**New Mark Homes**

Re: 2602 SW Farm Field Rd

Lot 39 Hook Farms Lee's Summit, MO

Permit#: PRRES20216094

## **OVER RAISE WOOD FLOOR - FRAMING ANCHOR OPTION**

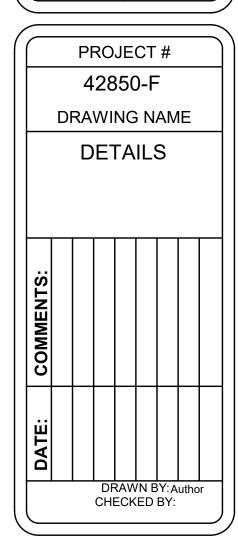
- CS-PF at breakfast wall
  - Interior side of west exterior wall shall be braced with 7/16" thick wood structural panel and fastened per CS-PF requirements with strapping.
     Minimum width of panel shall be 16". Simpson DTT2Z tie downs between floors shall be attached at each end of braced panel as shown on detail 1/S5.0.
